Answer to Reviewer 1

We would like to thank both reviewers for their thorough review of our manuscript. They have raised a number of points that require clarifications or corrections in the manuscript. Please find below the comments of the Reviewer 1 (using blue fonts), along with our corresponding answer to each comment (using black fonts).

Answer to Reviewer 2

Figure 1. Power ratio, measured power divided by the theoretical produced power using a hub height wind speed, for different wind shear and veer values estimated over 10-minute periods.

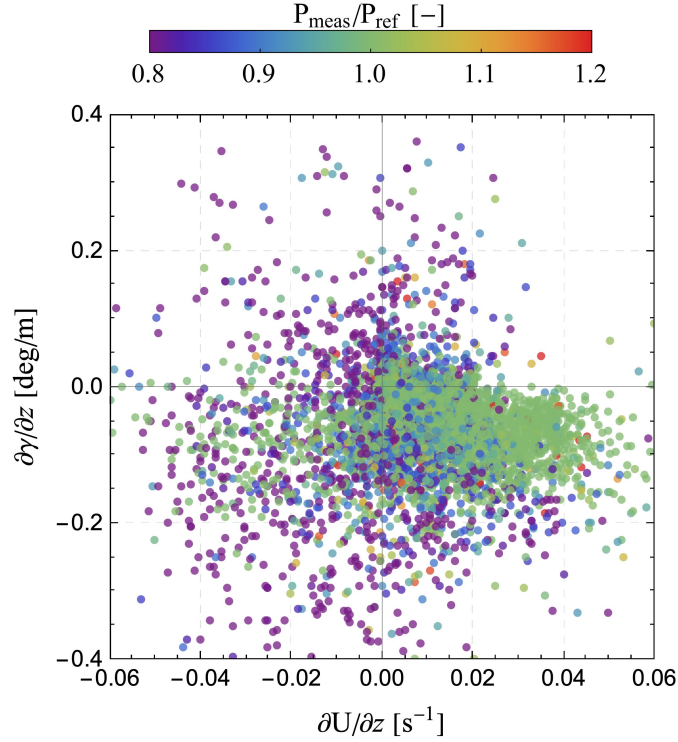
- Figure 6 conveys important information from the current study. It would be interesting to plot the power ratio as a function of the wind shear gradient to examine whether the power discrepancy is related to the magnitude of negative shear.

The power curve results in Fig. 6 are going to be dependent on the accuracy of the hub-height wind speed. Since we don't have measurements at the lower part of the rotor it is not straightforward to assess what were the REWS in the case of the wind profiles with a negative shear. Therefore the main message that we want to convey with this plot is that the power curve verification offshore should not rely on solely on hub height wind speeds.

Following the suggestion of the reviewers we plot the power ratio (measured power divided by the theoretical produced power using a hub height wind speed) as a function of both the shear and veer of the wind. The results are presented in the following figure. We have decided to add this figure in the Appendix and added the following comment on the end of the line 295:

The variation of the produced power are attributed to both the shear and veer values of the wind profile. In the examined dataset negative shear values are usually related to negative veer values which results in reduction to the power production (see Appendix C). This result is in agreement with the findings reported by Murphy et al. (2020) and Paulsen et al. (2026) for case of onshore and offshore fixed-bottom wind turbines, respectively.

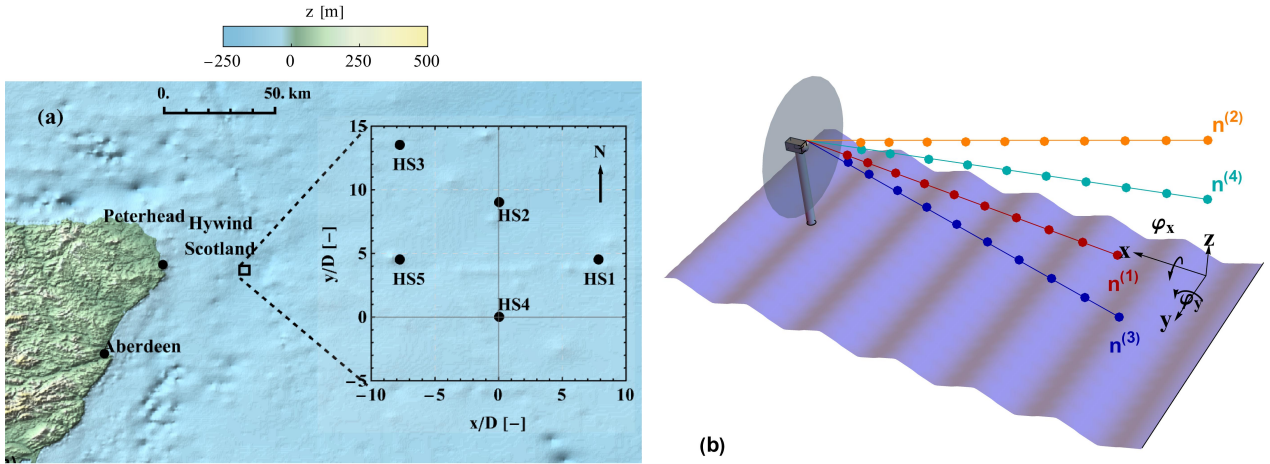
1. Section 2.1: this has only one paragraph denoting the field study, most of this subsection is about the magnitude of the angles of motion of the FOWT. What is missing is the description of the field campaign, layouts of the turbines in the wind farm and the location of the lidar. While the entire description need not be repeated from (Angelou et al., 2023), this section is missing essential information, one example being the north orientation of the turbine/wind farm, since several wind directions are mentioned in the rest of the manuscript without any reference to the reader.

8. *Figure 1: This figure is quite confusing, as the line indicating the rotor is not tilted by 5° , but the dots indicating the range gates of the lidar beams are shown based on the average turbine tilt of 5° . Please consider aligning this for sake of consistency.*

We agree with the reviewer that more information should have been added here. This was partly done to not repeat a lot of information already mentioned in the article Angelou et al. (2023). The first paragraph of Section 2.1 is now rewritten and a new figure has been added that also shows the two rotations that have been considered in this study. The updated paragraph is the following:

Furthermore, we have added the information about in which wind turbine was the nacelle-mounted wind lidar installed.

We have updated the figure by tilting the rotor in both subplots.

Figure 2. Histogram of the standard deviation of the yaw direction.

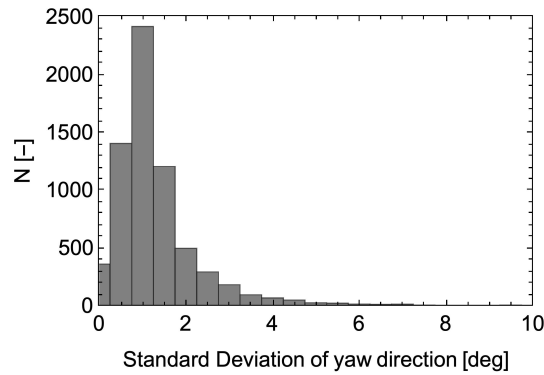
5. L. 123: During the yawing motion, is care taken to avoid considering these scans? please mention that here. Why is this number specifically chosen ($< 10^\circ$), do the coordinates not get distorted when turbine yaw standard deviation is 9° for a selected 10-min period? Please elaborate on this in the discussion section.

Overall, the standard deviation of the yaw was very low (i.e. average value of less than 3 degrees). However, there were few cases where the standard deviation was large. A histogram of the standard deviation is presented below:

We have added the following sentence in second paragraph of the Discussion:

Another source of uncertainty in estimating the hub-height wind speed is the dynamic variation of the yaw direction. To minimize potential biases, only periods with a yaw direction standard deviation below 10° were considered. This threshold was chosen empirically. The resulting dataset is characterized by an average yaw direction standard deviation of 2.6° , indicating that the impact of yaw motion variability is expected to be minimal.

Figure 3. Bar-chart of the RMSE values of the model used to predict the radial wind speed measurements of the nacelle-mounted wind lidar per different months.

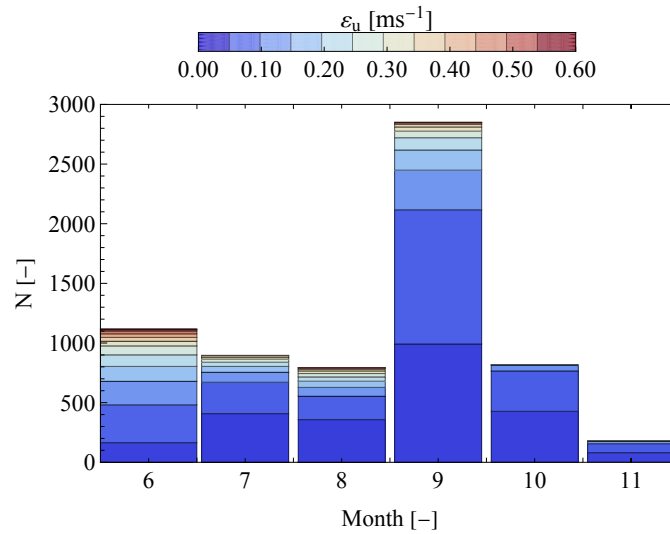
17. L. 204ff: even though a month-wise distribution is shown in the appendix, please include a table of the RMSE for the bins of your empirical conditions to discard a case. Seeing this in tabular form or through a figure will further help the reader associate it to a potential LLJ.

We are not sure if we have understood correctly the comment of the reviewer. We have drawn a bar-chart of the rmse values per month, where it is shown that the higher values are found during the months from June to August (see figure below). If the reviewer thinks that this figure is relative we can add it as an Appendix in our manuscript.

Figure 4. Comparison the estimated hub-height wind speed and of the REWS with the wind speed measured by the nacelle-mounted anemometer

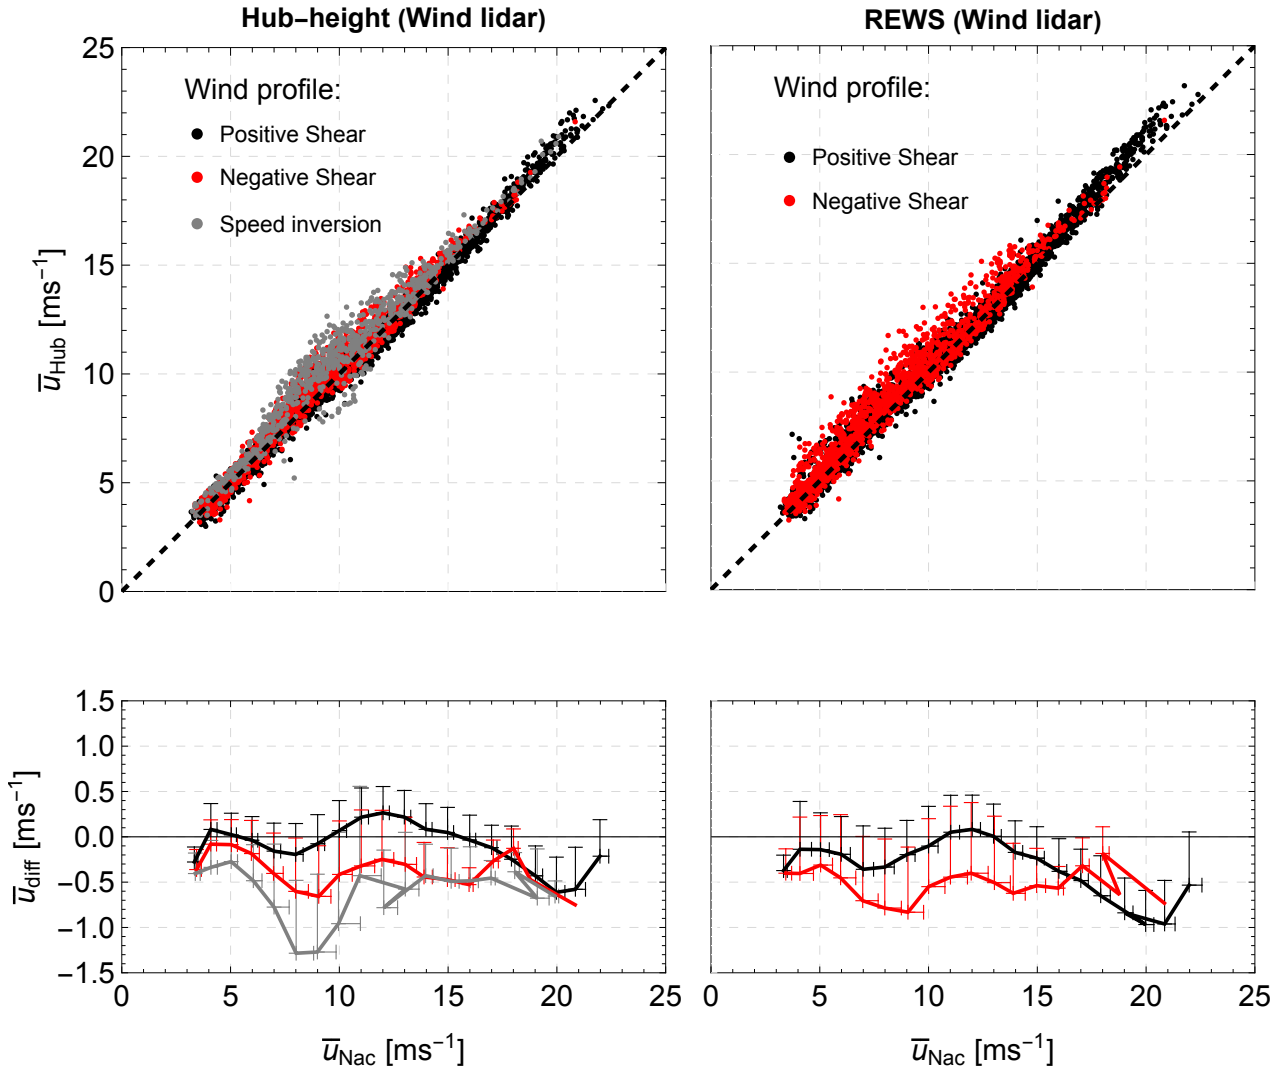
21. L. 255: Did the author make sure that the calibration of the nacelle mounted anemometer was proper and that measurements were in the calibrated wind speed range/operating regime?

Unfortunately we don't have any information regarding the calibration of the nacelle-mounted anemometer, so the results of the calculation of the vertical offset of the lidar are dependent on the assumption that the nacelle-mounted anemometer is calibrated properly. However, we would like to note here that that the estimated height offset is in a good agreement with the measured location of the nacelle-mounted wind lidar.

In the following figure we present the agreement of the estimated hub-height wind speed and of the REWS with the wind speed measured by the nacelle-mounted anemometer for different wind profile characteristics. We observe that in the cases where a negative shear is found the deviation between the hub-height wind speed based on the nacelle-mounted Doppler lidar and the corresponding ones of the sonic anemometer increase.
